TRANE®

Confidential Service Bulletin

Insulated Bearing and Brush Kit

For units with LF2.0 drives

Figure 1. Photo of typical spark discharge damage in a bearing race

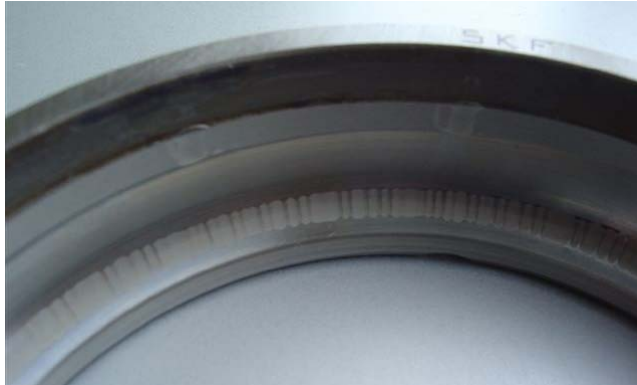
A situation may occur in some LF 2.0 equipped CVHF units where the chiller motor experiences a shaft voltage. The shaft voltage created may seek a path to ground through the thrust bearings, resulting in damage to the thrust bearing.

If a LF 2.0 AFD equipped CVHF chiller with steel bearing BRG01210 is determined to have suffered a premature or repeat thrust bearing failure due to spark discharge, then Trane has available to install an insulated bearing assembly, a new design grounding brush, and a bearing inspection cover that allows the fitting of the new design brush.

For an LF 2.0 equipped CVHF chiller with a standard steel thrust bearing BRG01210 that has failed due to spark discharge, with or without a brush kit: Order and install the insulated bearing assembly, new design brush, and (if needed) a new bearing inspection cover. See the parts ordering information below for details.
